RE: License Amendment Request for Pennsylvania State University Breazeale Reactor, License R-2, Docket 50-005: Change in Organizational Structure.

The following table describes the proposed changes from Version 40 to Version 41 of the reactor technical specifications:

TECHNICAL SPECIFICATIONS: PENN STATE BREAZEALE REACTOR (PSBR)
FACILITY LICENSE NO. R-2

ORGANIZATION CHART

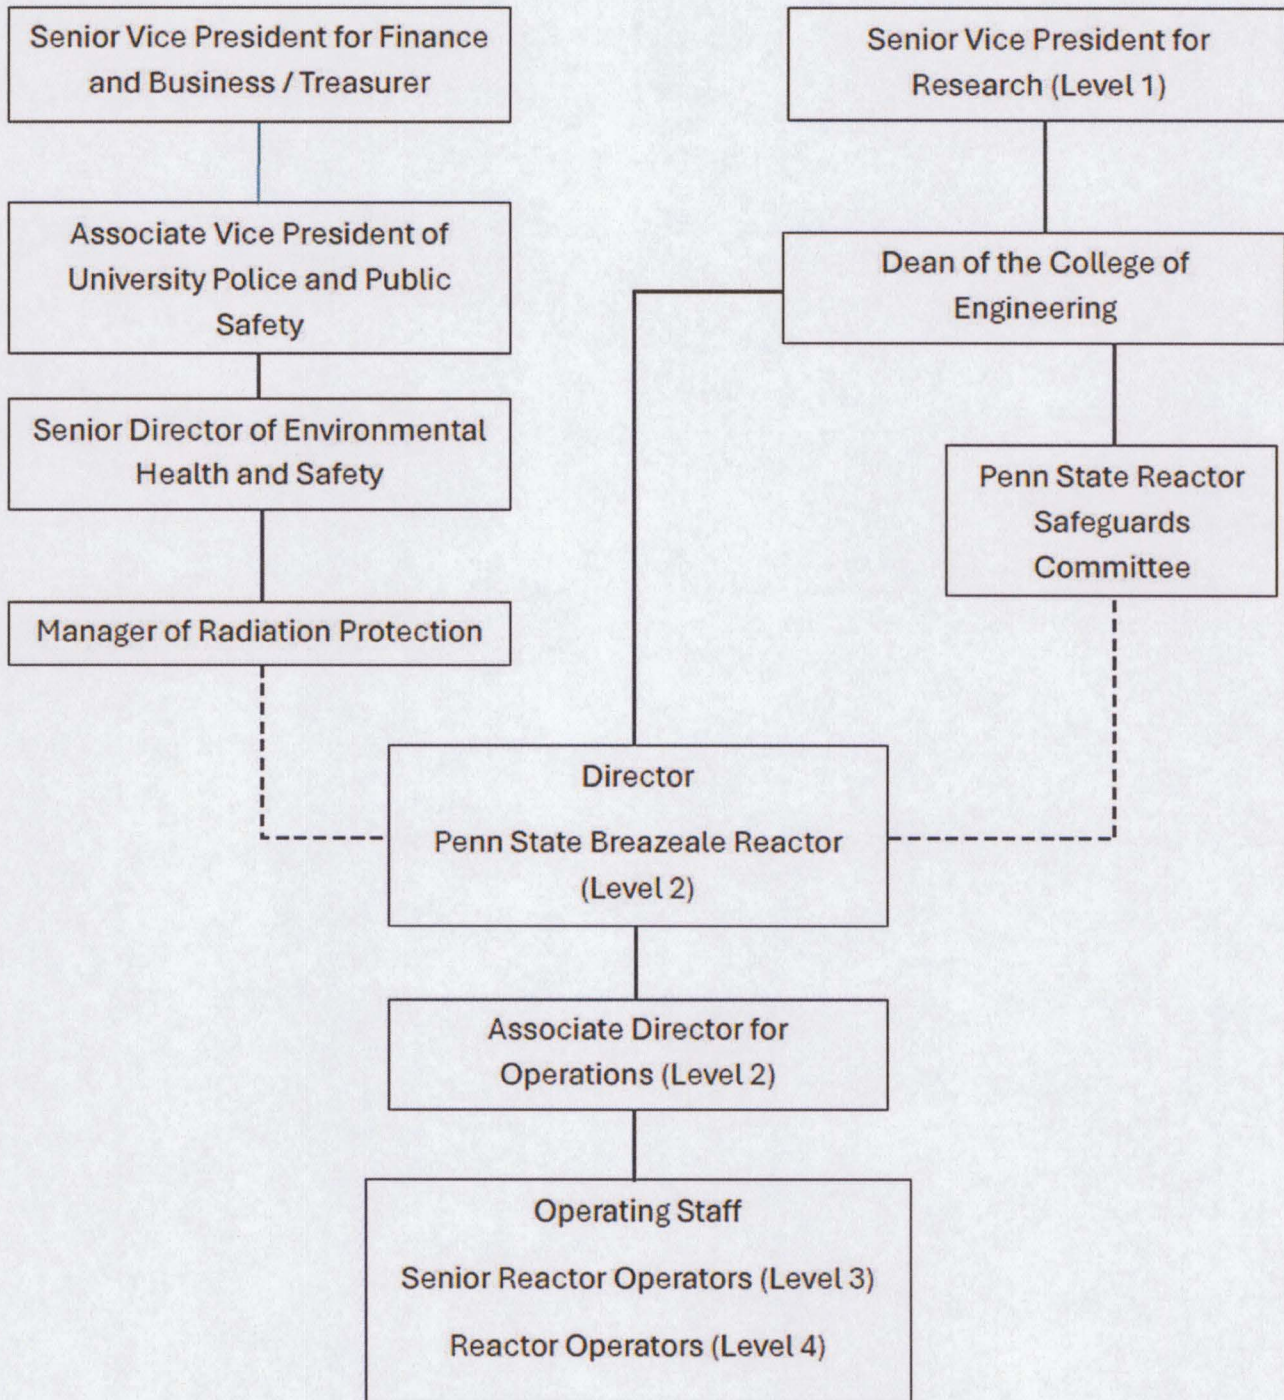
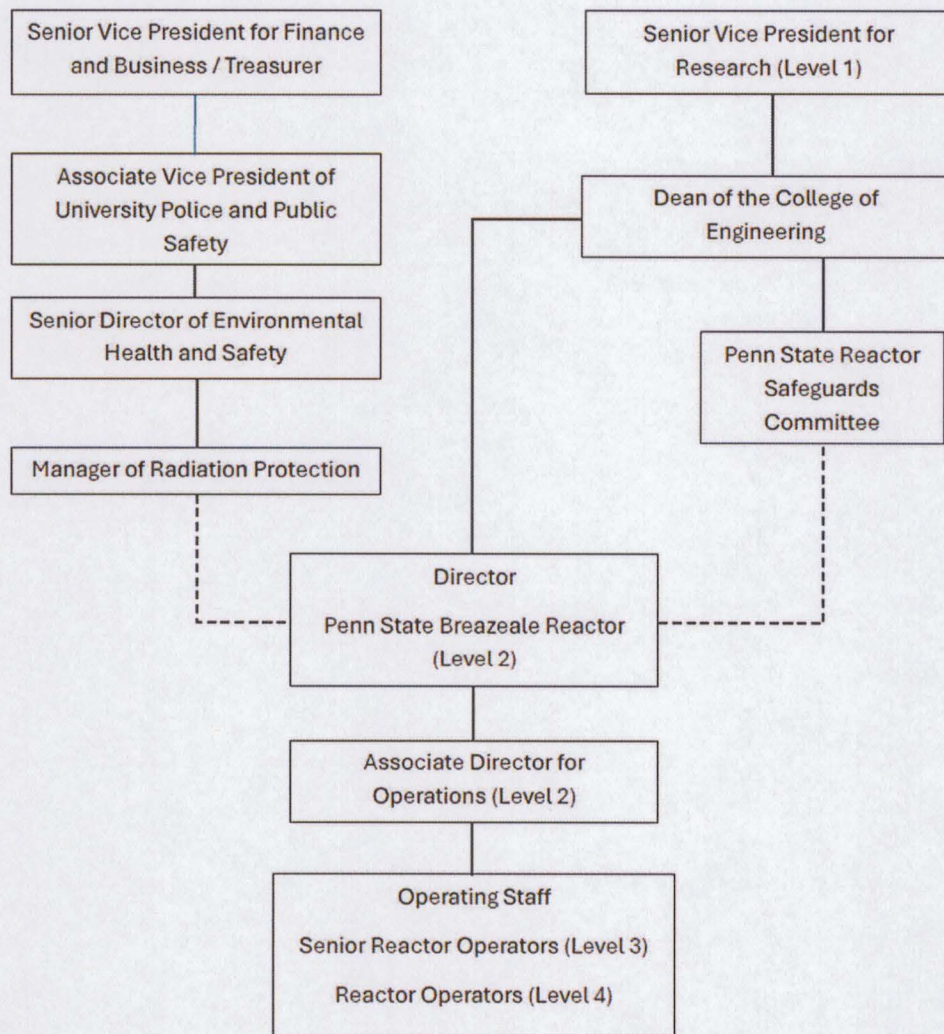
The Pennsylvania State University requests an amendment to the Breazeale Nuclear Reactor license (R-2) to be effective on July 1, 2025, in order to incorporate a proposed change to the organizational structure in the facility Technical Specifications (TS). Specifically, it is proposed that the Director of Environmental Health and Safety (EHS) shall report to the Associate Vice President of University Police and Public Safety (UPPS) instead of to the Vice President for the Office of the Physical Plant (OPP). Additionally, the title "Director of Environmental Health and Safety" is updated to "Senior Director of Environmental Health and Safety" in both the organizational chart and in the text of TS 6.1.1. All other aspects of the organizational chart remain the same as before.

An associated change is in the text of TS 6.1.1, in which the description of the organization is revised by removing the Assistant Vice President for Safety and Environmental Services, which is a secondary title held by the Senior Director of EHS and is therefore redundant, and including the Associate Vice President of University Police and Public Safety to reflect the aforementioned change in the organization chart. There is no mention of the VP of the Physical Plant in the current revision of TS 6.1.1, although this office is included in the organizational chart.

Section 6.1.1	<p>The text of the “Structure” section is changed such that title of Associate Vice President of University Police and Public Safety was put in place of the Assistant Vice President for Safety and Environmental Services. The latter is a secondary title held by the Director of Environmental Health and Safety.</p> <p>The title “Director of Environmental Health and Safety” is updated to “Senior Director of Environmental Health and Safety.”</p>
Chapter 6 Organization Chart	<p>“Associate Vice President of University Police and Public Safety” was put in place of “Vice President for Physical Plant.”</p> <p>The title “Director of Environmental Health and Safety” is updated to “Senior Director of Environmental Health and Safety.”</p>

The Manager of Radiation Protection reports through the Senior Director of Environmental Health and Safety and the Associate Vice President of University Police and Public Safety, and to the Senior Vice President for Finance and Business/Treasurer. The qualifications for the Manager of Radiation Protection position are the equivalent of a graduate degree in radiation protection, 3 to 5 years experience with a broad byproduct material license, and certification by The American Board of Health Physics or eligibility for certification.

The Manager of Radiation Protection reports through the Senior Director of Environmental Health and Safety ~~and, the assistant Vice President for Safety and Environmental Services, and the Associate Vice President of University Police and Public Safety, and~~ to the Senior Vice President for Finance and Business/Treasurer. The qualifications for the Manager of Radiation Protection position are the equivalent of a graduate degree in radiation protection, 3 to 5 years experience with a broad byproduct material license, and certification by The American Board of Health Physics or eligibility for certification.
